RE: Hillsborough County Southeast County Landfill
Facility Final Build-Out Conceptual Environmental Resource Permit Application
Response to Request for Additional Information
File No. 29-0270881-004

**SOUTHEAST COUNTY LANDFILL
FACILITY FINAL BUILD-OUT
CONCEPTUAL ENVIRONMENTAL
RESOURCE PERMIT APPLICATION**

RESPONSE TO REQUEST FOR ADDITIONAL INFORMATION

**RESPONSE TO FDEP
REQUEST FOR ADDITIONAL
INFORMATION**

CERTIFICATE OF AUTHORIZATION #1841	DATE	PROJECT NO.
APPROVED BY	05/2008	08449-030-02
JEFFREY D. PEQUEEN, P.E.	SCALE	DWG. NO.
P.E. # 47664	AS SHOWN	3

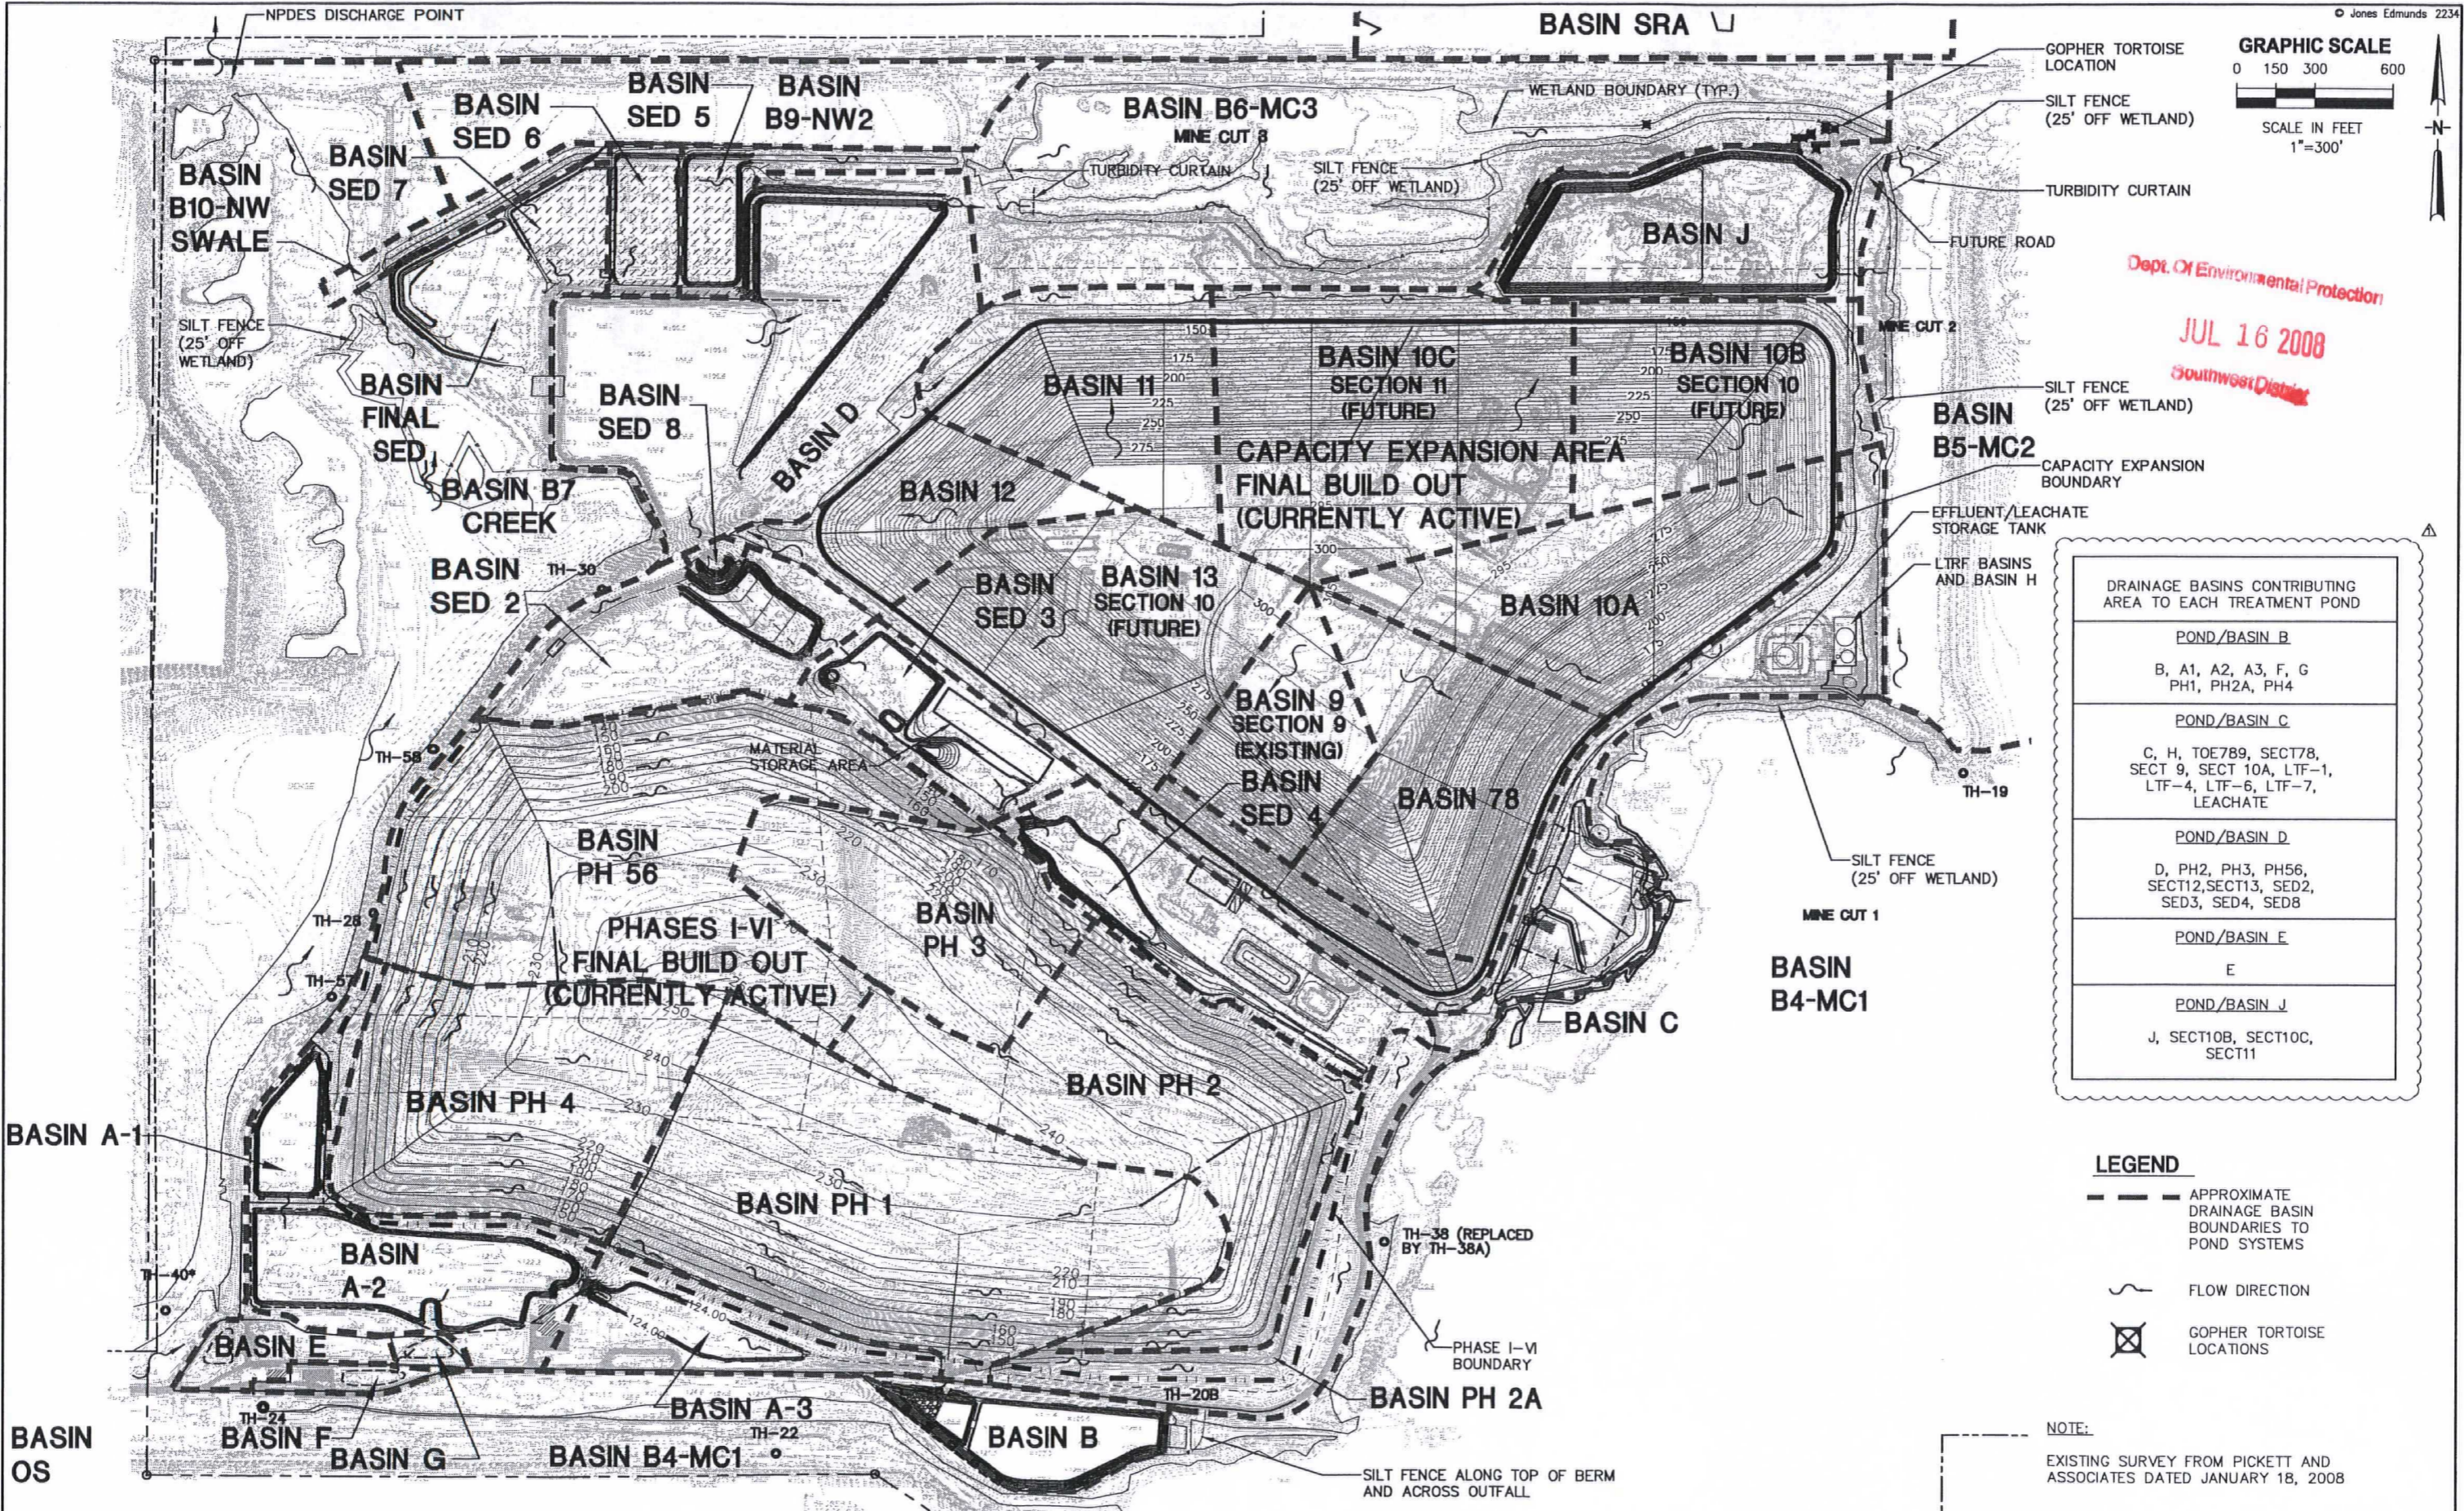
Comment 6: In the conceptual project area, please locate all landfill cells that are proposed, currently in operation or which have been closed. Please refer to Application Section E, Part III, Items L & R.

Comment 7: Please clarify what material will be stored in the material storage area on the sheet No. 6. Please refer to Application Section E, Part III, Item L.

Response 6: Phases I-VI and the Capacity Expansion Area Sections 7 and 8 are the currently active cells. Section 9 has recently been constructed and is in the process of obtaining operations approval with FDEP. The remaining sections of the CEA, including Sections 10, 11, and 12, are future Class I Landfill sites. None of the areas shown are currently closed. The revised Drawings 6 and 7 are provided in Attachment 1.

Response 7: The material storage area will include piping, geosynthetic material, gravel, and other items for operation and construction of the landfill site.

STORMWATER MANAGEMENT PLANS
POND PLAN

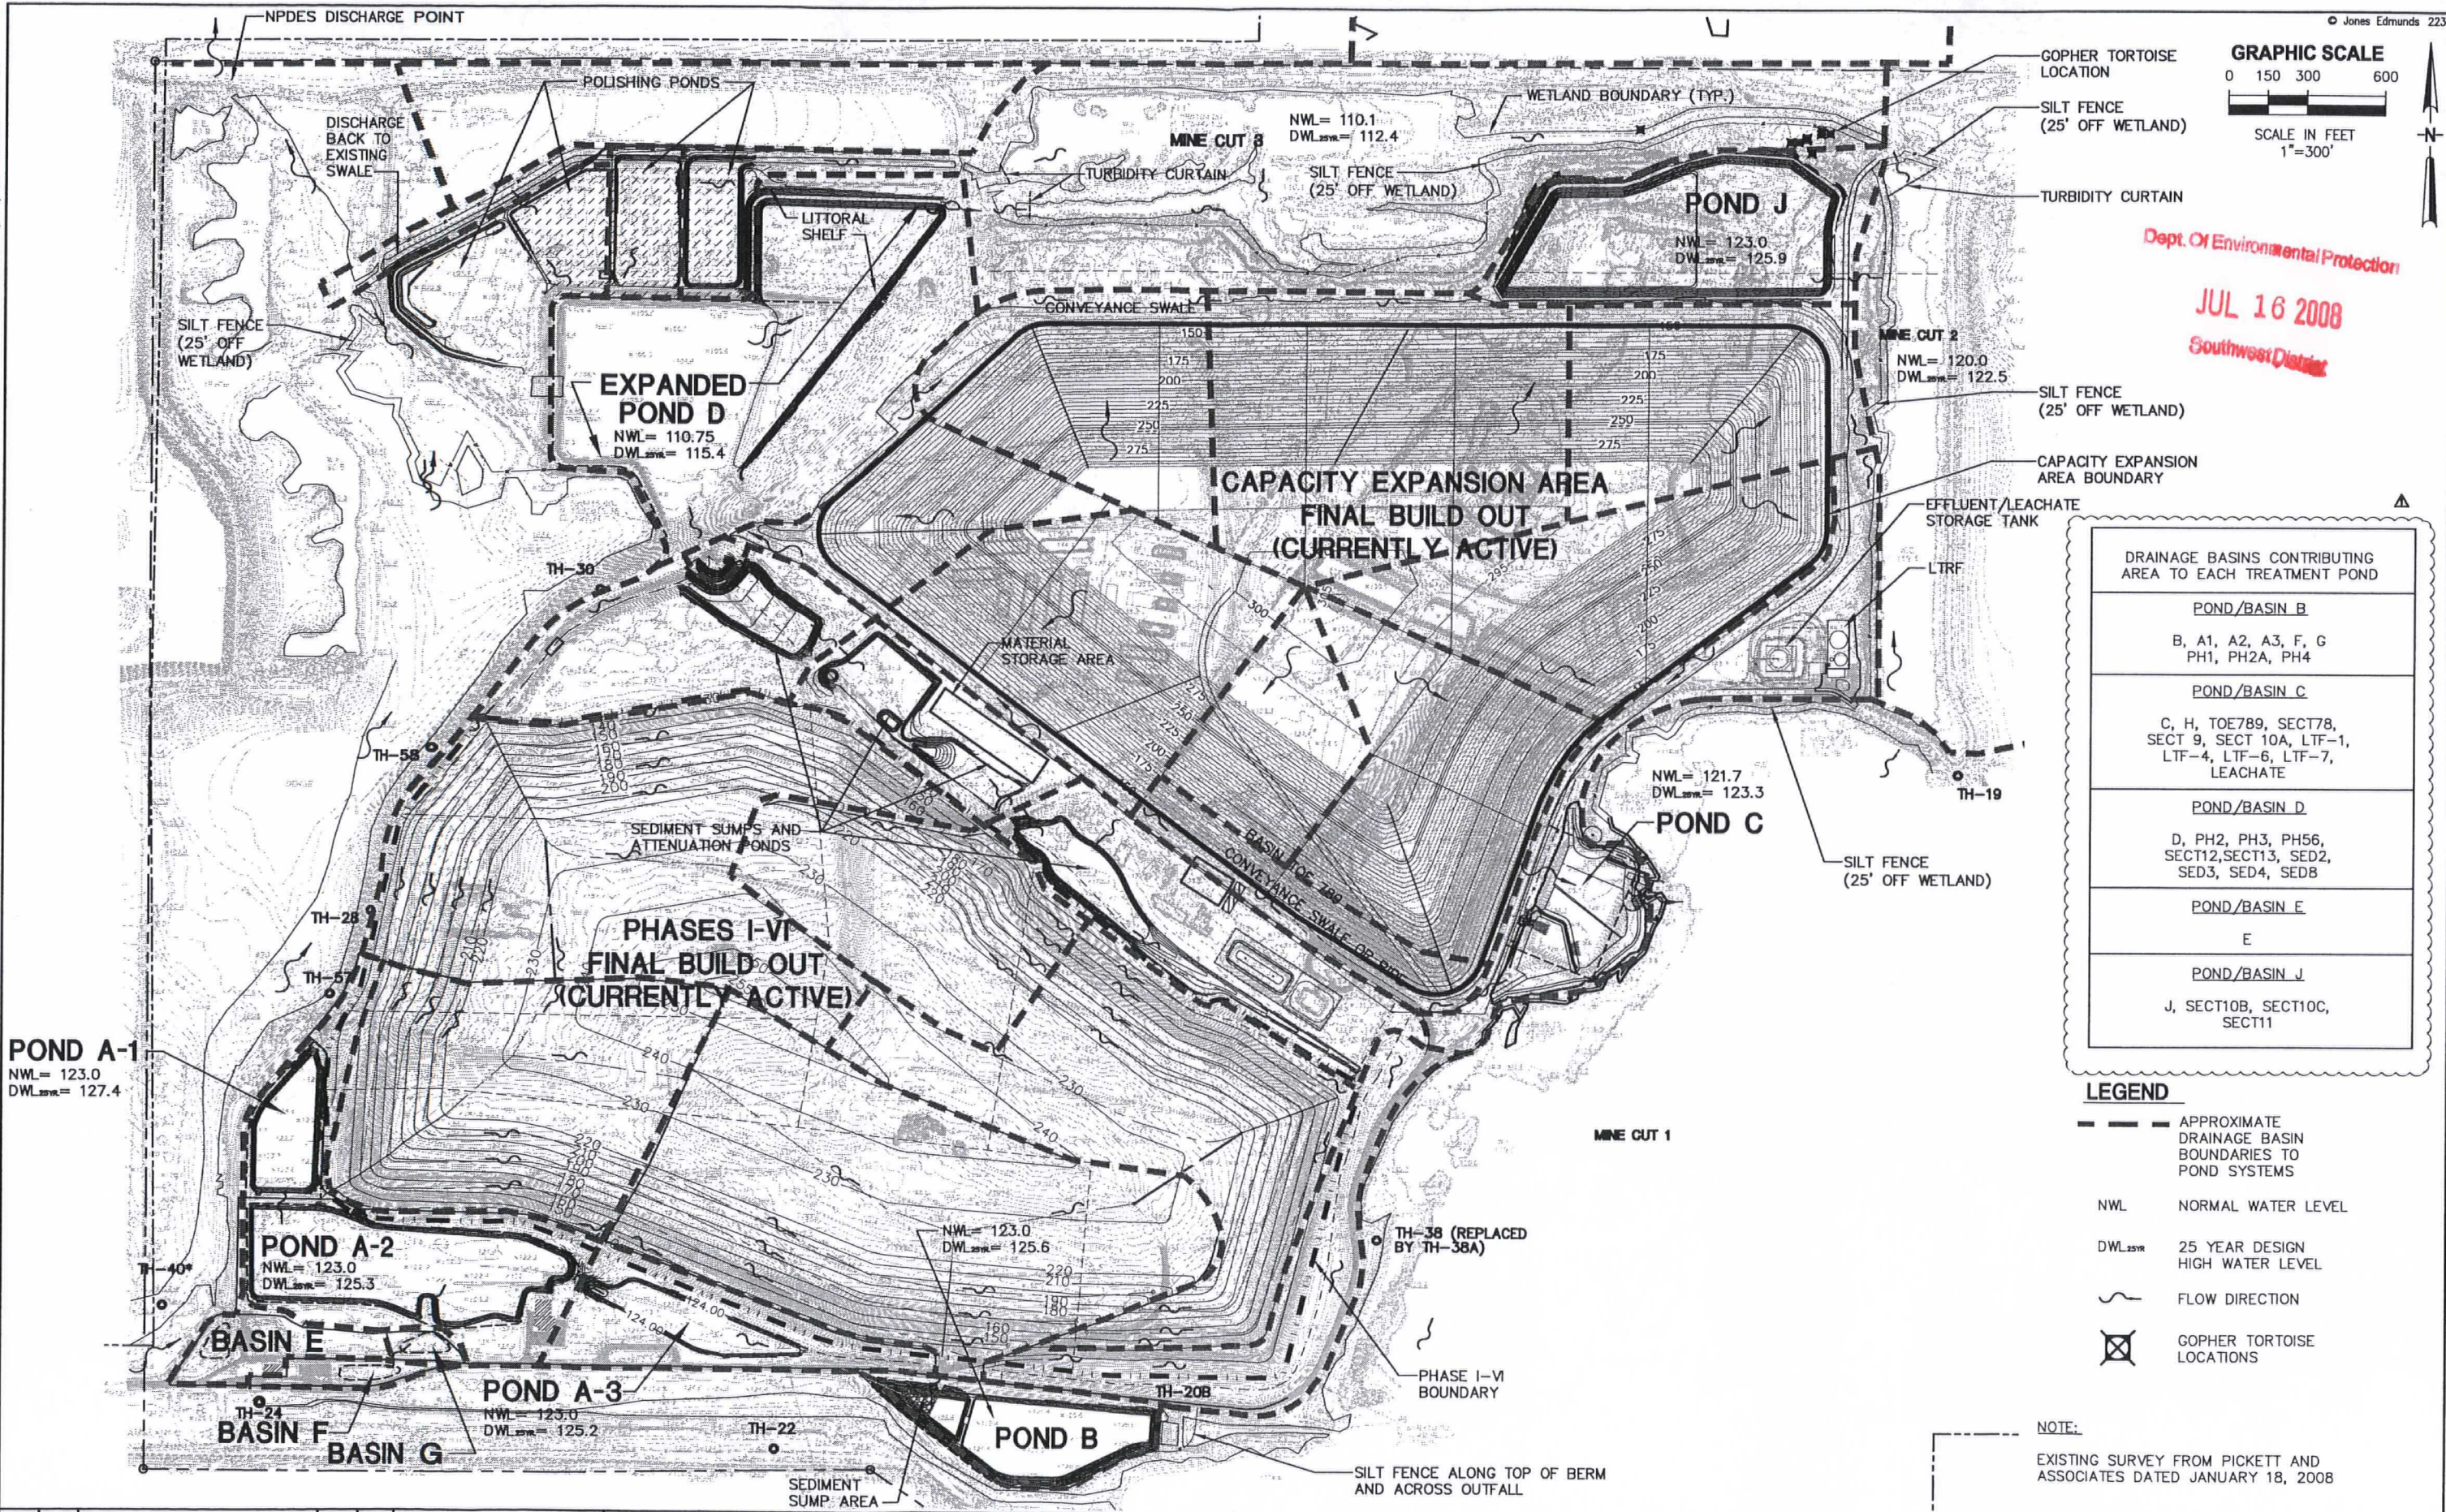
Comment 4: Were pre vs. post drainage patterns provided? Please refer to Application Section E, Part III, Item I.

a. Please indicate what SWMS will serve the existing tire area in Basin B. Please provide drainage arrows.

b. Please indicate what SWMS will serve the CEA and provide drainage arrows. Please refer to Application Section E Part III, Item I & O.

Response 4: Due to the large amount of data on the plans, the pre-development and post-development drainage patterns are shown on different plans. Figure 2.0 provided in the application details the pre-development patterns. Drawings Number 6 and 7 in the plan set detail the post-development drainage patterns. Additional drainage arrows have been added to these drawings to further clarify the patterns. The revised Drawings 6 and 7 are provided in Attachment 1.

Response 9b: Additional drainage arrows have been added to Drawings 6 and 7 to further clarify the CEA drainage. Additionally, a table has been added to these plans to specifically define all of the sub-basins draining to each pond. The revised drawings are provided in Attachment 1.
